CA MUTCD 2026 Figure Markups (Draft)

This "Figure Comparisons" document has been prepared by Caltrans to share the changes that are reflected in CA MUTCD 2026 initial draft version figures, when compared to National MUTCD 2023 figures, as well as current CA MUTCD 2014 Revision 8 figures (which were based on National MUTCD 2009). This document identifies California specific figures that are incorporated into CA MUTCD 2026 initial draft version and figures that are not incorporated and provides brief explanation, if they aren't incorporated. This document is being provided for ease in comparison, when reviewing CA MUTCD 2026 initial draft.

Figure 7B-1. Signs in School Areas and at School Crossings (Sheet 1 of 2)

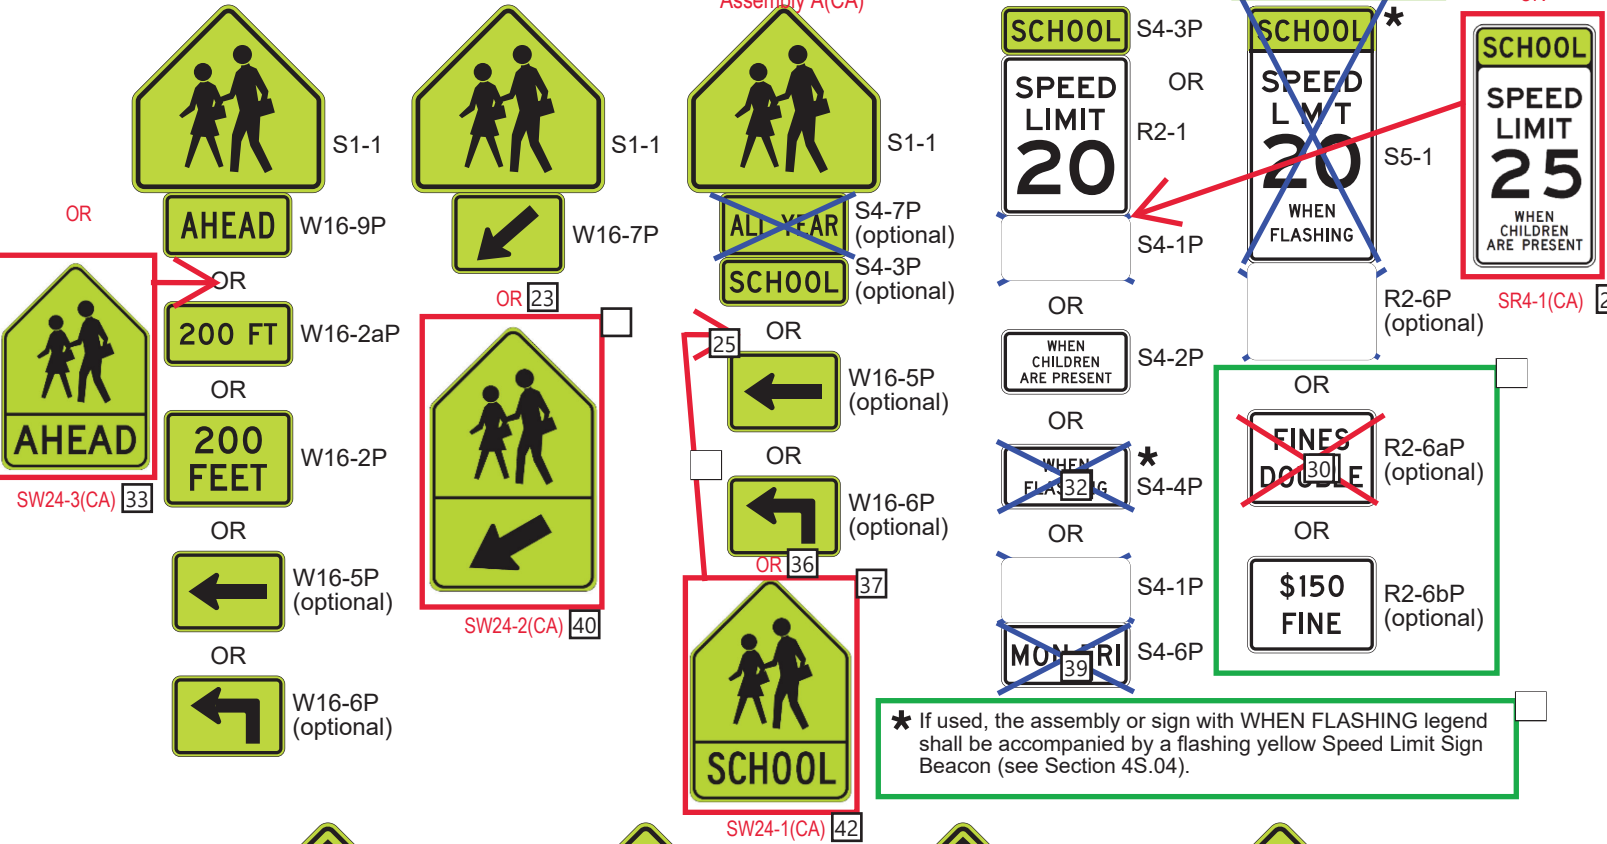
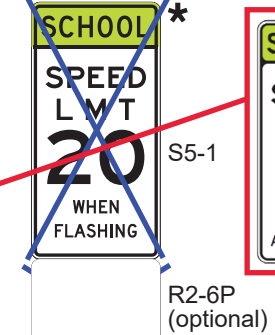
Number: 1	Author: s116730	Subject: Highlight	Date: 7/25/2024 9:46:00 AM
NMUTCD 2023 changed the title of Figure 7B-1 from "School Area Signs" to "Signs in School Areas and at School Crossings" and incorporated signs from NMUTCD 2009 Figures 7B-1 and 7B-6 and added sub-headings A thru D, expanding Figure 7B-1 into 2 sheets.				
NMUTCD 2023 added sign codes for all signs, which were missing in NMUTCD 2009 figures				
	Number: 2	Author: s116730	Subject: Highlight	Date: 7/25/2024 9:46:06 AM
NMUTCD 2023 added sub-heading A				
	Number: 3	Author: s116730	Subject: Cross-Out	Date: 7/8/2024 11:11:18 AM
	Number: 4	Author: s116730	Subject: Highlight	Date: 7/25/2024 9:46:13 AM
NMUTCD 2023 added new text				
	Number: 5	Author: s116730	Subject: Text Box	Date: 7/9/2024 3:32:56 PM
D(CA)				
	Number: 6	Author: s116730	Subject: Text Box	Date: 7/9/2024 4:02:20 PM
C(CA)				
	Number: 7	Author: s116730	Subject: Text Box	Date: 7/9/2024 3:33:04 PM

Number: 20	Author: s116730	Subject: Rectangle	Date: 7/9/2024 3:56:19 PM
Add SW24-3(CA) image in Assembly D(CA) between the W16-9P and W16-2aP				
	Number: 21	Author: s116730	Subject: Line	Date: 7/8/2024 11:12:25 AM
	Number: 22	Author: s116730	Subject: Line	Date: 7/8/2024 11:12:17 AM

Number: 23	Author: s116730	Subject: Text Box	Date: 7/9/2024 3:57:09 PM
				OR
	Number: 24	Author: s116730	Subject: Text Box	Date: 7/9/2024 4:04:01 PM
				SR4-1(CA)
	Number: 25	Author: s116730	Subject: Line	Date: 7/9/2024 4:07:36 PM
	Number: 26	Author: s116730	Subject: Rectangle	Date: 7/9/2024 3:59:42 PM
	Add SW24-2(CA) image in Assembly D(CA) below the W16-7P			
	Number: 27	Author: s116730	Subject: Line	Date: 7/9/2024 4:06:50 PM
	Number: 28	Author: s116730	Subject: Rectangle	Date: 7/13/2024 10:03:54 AM
	NMUTCD 2023 added new signs			
	Number: 29	Author: s116730	Subject: Line	Date: 7/8/2024 11:16:39 AM
	Number: 30	Author: s116730	Subject: Line	Date: 7/8/2024 11:16:39 AM
	Number: 31	Author: s116730	Subject: Line	Date: 7/8/2024 10:57:28 AM
	Number: 32	Author: s116730	Subject: Line	Date: 7/8/2024 10:57:13 AM
	Number: 33	Author: s116730	Subject: Text Box	Date: 7/9/2024 3:56:26 PM
				SW24-3(CA)
	Number: 34	Author: s116730	Subject: Line	Date: 7/8/2024 10:58:34 AM

Number: 35	Author: s116730	Subject: Line	Date: 7/8/2024 10:58:34 AM
	Number: 36	Author: s116730	Subject: Text Box	Date: 7/9/2024 3:57:52 PM
				OR
	Number: 37	Author: s116730	Subject: Rectangle	Date: 7/9/2024 3:47:20 PM
	Add SW24-1(CA) image in Assembly A(CA) between the S4-3P and W16-5P			
	Number: 38	Author: s116730	Subject: Line	Date: 7/8/2024 10:58:51 AM
	Number: 39	Author: s116730	Subject: Line	Date: 7/8/2024 10:58:51 AM
	Number: 40	Author: s116730	Subject: Text Box	Date: 7/9/2024 3:58:56 PM
				SW24-2(CA)
	Number: 41	Author: s116730	Subject: Rectangle	Date: 7/13/2024 10:04:44 AM
	NMUTCD 2023 added new note			
	Number: 42	Author: s116730	Subject: Text Box	Date: 7/9/2024 3:57:21 PM
				SW24-1(CA)
	Number: 43	Author: s116730	Subject: Line	Date: 7/8/2024 11:13:52 AM
	Number: 44	Author: s116730	Subject: Line	Date: 7/8/2024 11:13:18 AM
	Number: 45	Author: s116730	Subject: Line	Date: 7/8/2024 11:13:52 AM

Figure 7B-1. Signs in School Areas and at School Crossings ¹ (Sheet 2 of 2)

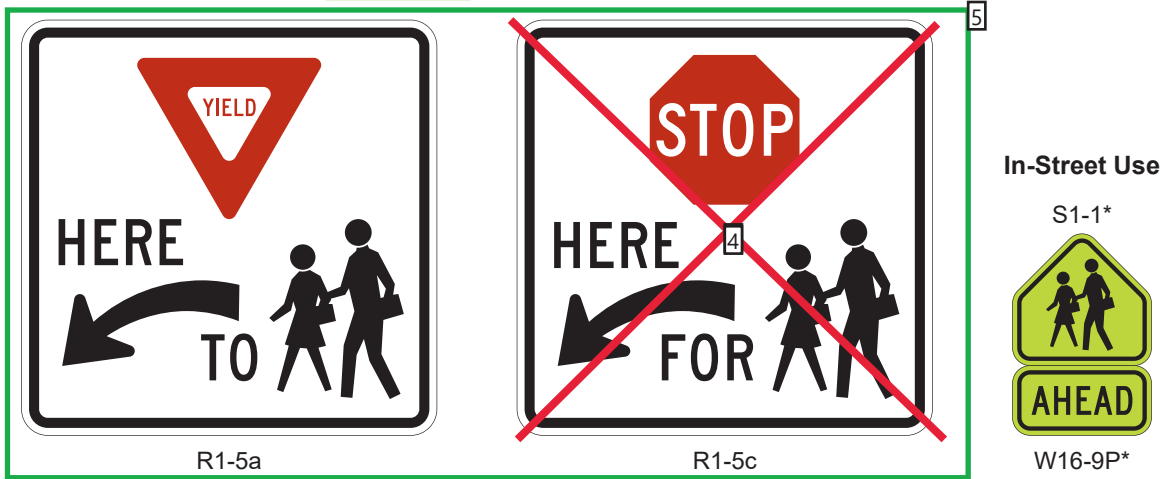
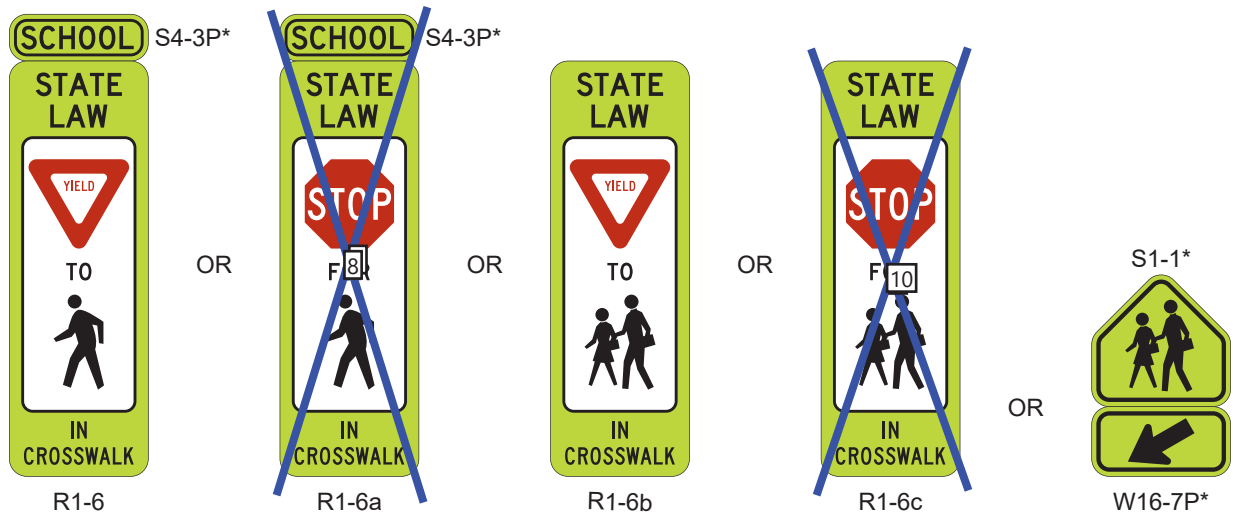
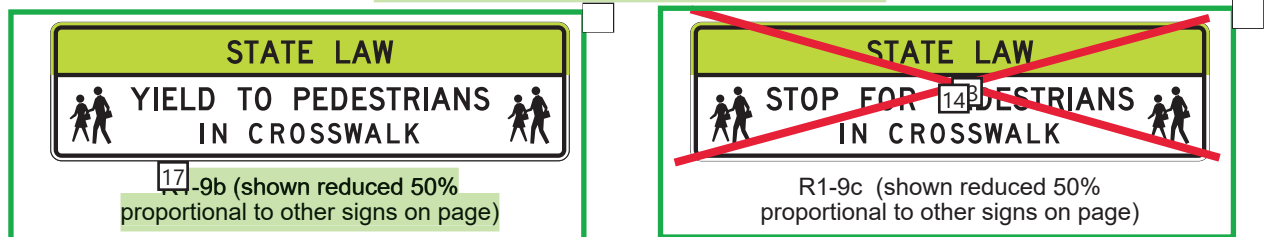
-
- Number: 1 Author: s116730 Subject: Highlight Date: 7/25/2024 9:46:47 AM
NMUTCD 2023 changed the title of Figure 7B-1 from "School Area Signs" to "Signs in School Areas and at School Crossings" and incorporated signs from NMUTCD 2009 Figures 7B-1 and 7B-6 and added sub-headings A thru D, expanding Figure 7B-1 into 2 sheets.

- NMUTCD 2023 added sign codes for all signs, which were missing in NMUTCD 2009 figures
-
- Number: 2 Author: s116730 Subject: Highlight Date: 7/25/2024 9:46:51 AM
NMUTCD 2023 changed sub-heading A in NMUTCD 2009 Figure 7B-6 to B
-

- Number: 3 Author: s116730 Subject: Line Date: 7/10/2024 8:44:02 AM
-
- Number: 4 Author: s116730 Subject: Line Date: 7/10/2024 8:44:02 AM
-
- Number: 5 Author: s116730 Subject: Rectangle Date: 7/13/2024 10:07:09 AM
NMUTCD 2023 added new signs
-

- Number: 6 Author: s116730 Subject: Highlight Date: 7/25/2024 9:47:03 AM
NMUTCD 2023 changed sub-heading B in NMUTCD 2009 Figure 7B-6 to C
-
- Number: 7 Author: s116730 Subject: Line Date: 7/14/2024 8:17:45 AM
-

- Number: 11 Author: s116730 Subject: Highlight Date: 7/25/2024 9:47:07 AM
NMUTCD 2023 added sub-heading D
-
- Number: 12 Author: s116730 Subject: Text Box Date: 7/9/2024 4:12:53 PM
Assembly E(CA)
-

- Number: 13 Author: s116730 Subject: Line Date: 7/10/2024 8:46:35 AM
-
- Number: 14 Author: s116730 Subject: Line Date: 7/10/2024 8:46:24 AM
-
- Number: 15 Author: s116730 Subject: Rectangle Date: 7/13/2024 10:07:36 AM
NMUTCD 2023 added new signs
-

- Number: 16 Author: s116730 Subject: Rectangle Date: 7/13/2024 10:07:27 AM
NMUTCD 2023 added text "IN CROSSWALK" as 3rd line in the sign
-
- Number: 17 Author: s116730 Subject: Highlight Date: 7/25/2024 9:47:24 AM
NMUTCD 2023 changed sign code from R1-9 in NMUTCD 2009 to R1-9b and added this text description.
-

- Number: 18 Author: s116730 Subject: Highlight Date: 7/25/2024 9:47:33 AM
-
- Number: 19 Author: s116730 Subject: Highlight Date: 7/25/2024 9:47:28 AM
NMUTCD 2023 added this text in the Note #1. Note #1 previously was in NMUTCD 2009 Figure 7B-6.
-

- Number: 20 Author: s116730 Subject: Highlight Date: 7/25/2024 9:47:38 AM
NMUTCD 2023 added new note

Figure 7B-1(CA). Signs in School Areas and at School Crossings

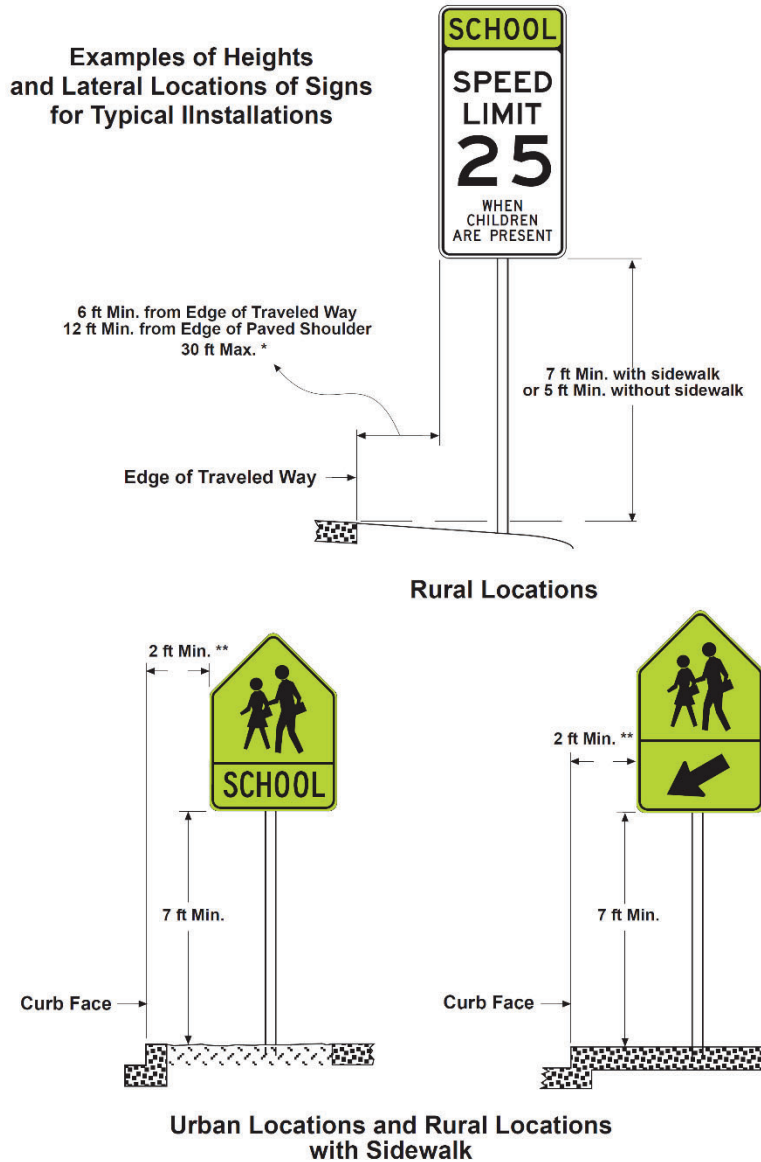
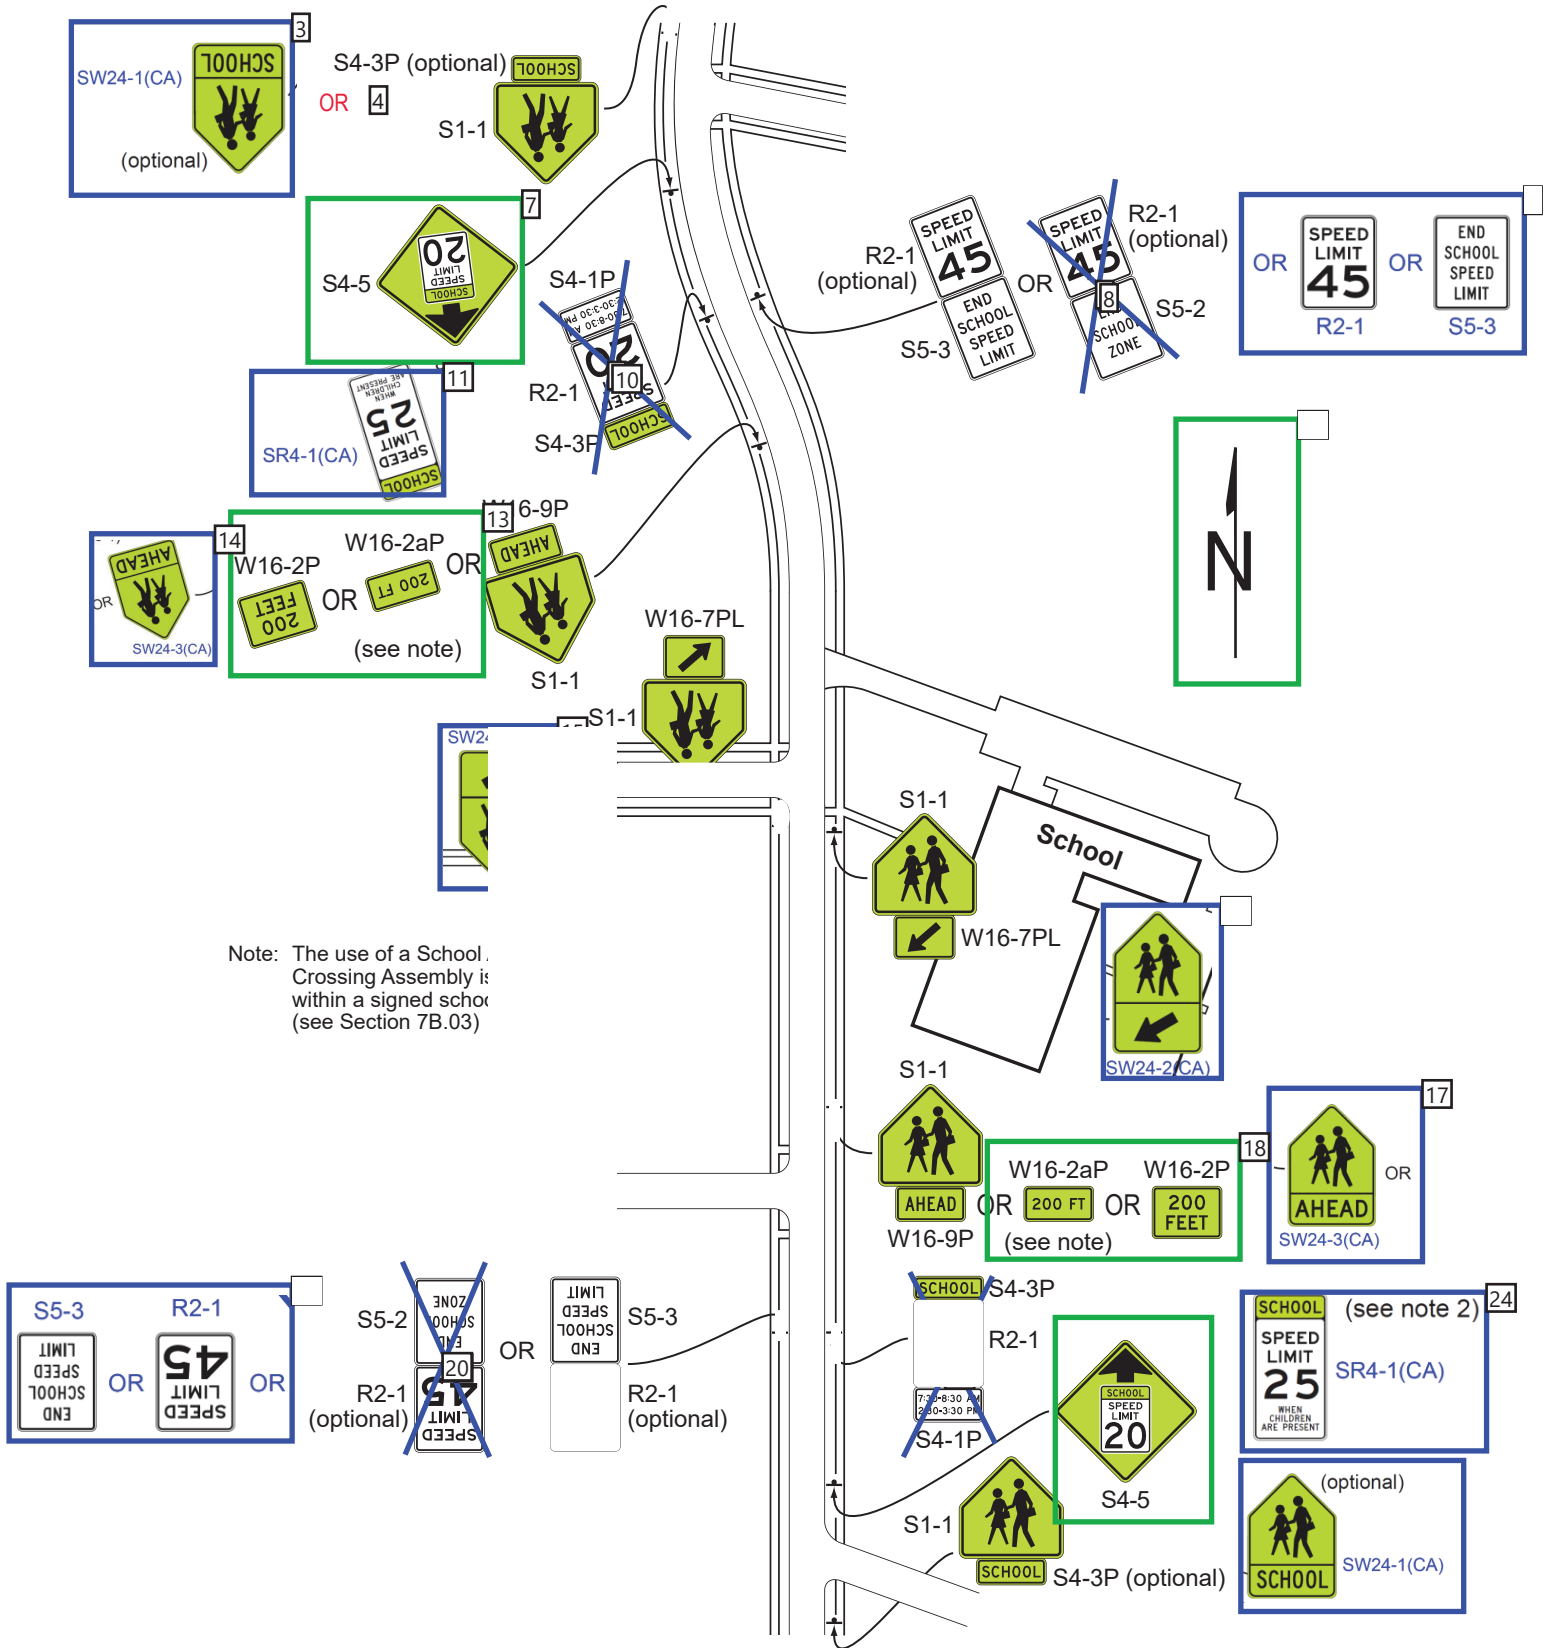
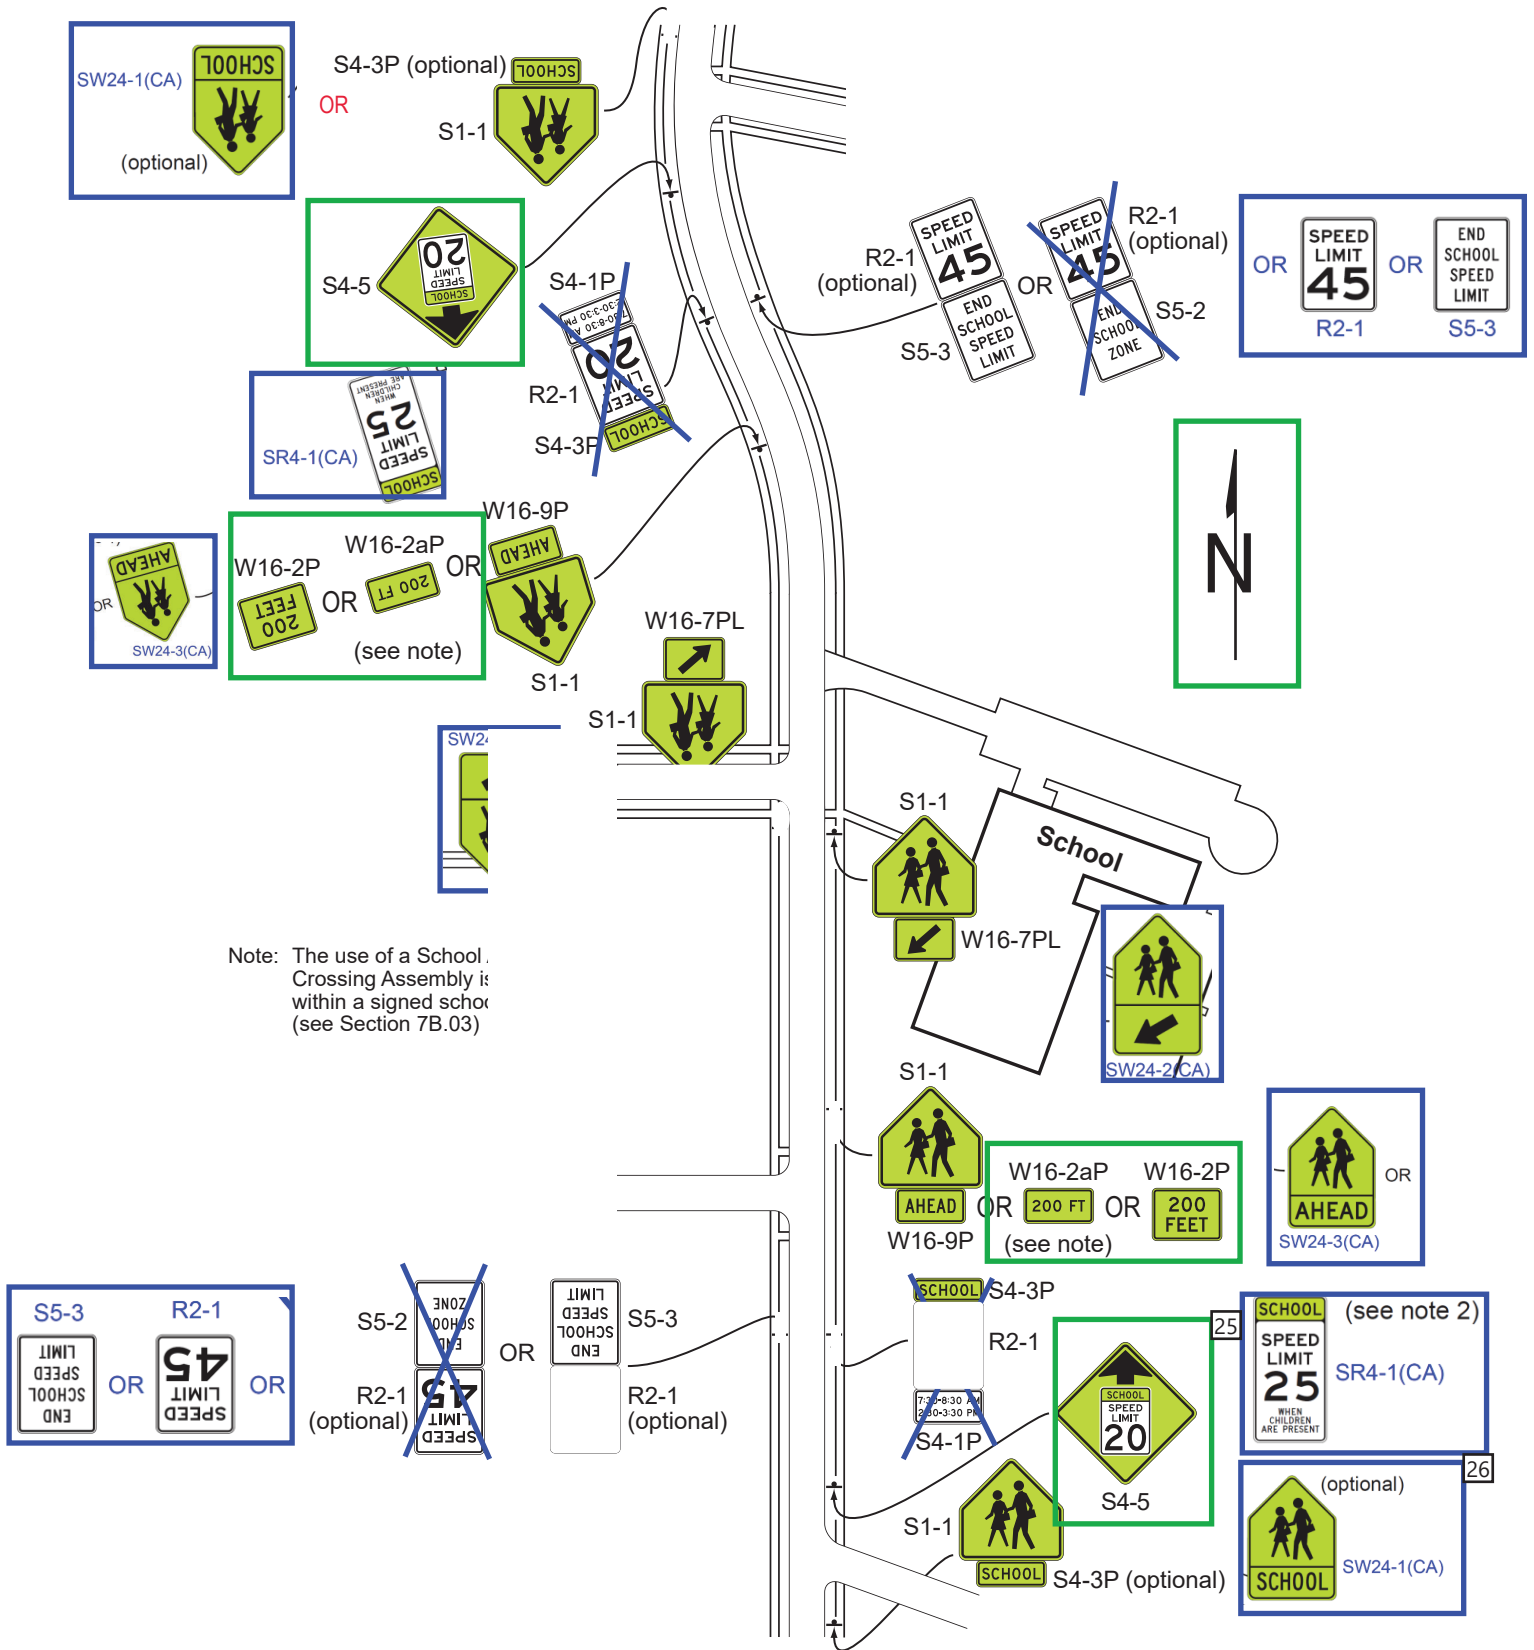
Number: 1 Author: s116730 Subject: Sticky Note Date: 7/16/2024 7:58:04 AM
Figure name changed to match NMUTCD 2023 Figure 7B-1 name and text for "(Sheet 2 of 2)" is deleted.

Number: 3 Author: s116730 Subject: Cross-Out Date: 7/25/2024 9:48:03 AM
NMUTCD 2023 changed the title of Figure 7B-1 from "School Area Signs" to "Signs in School Areas and at School Crossings"
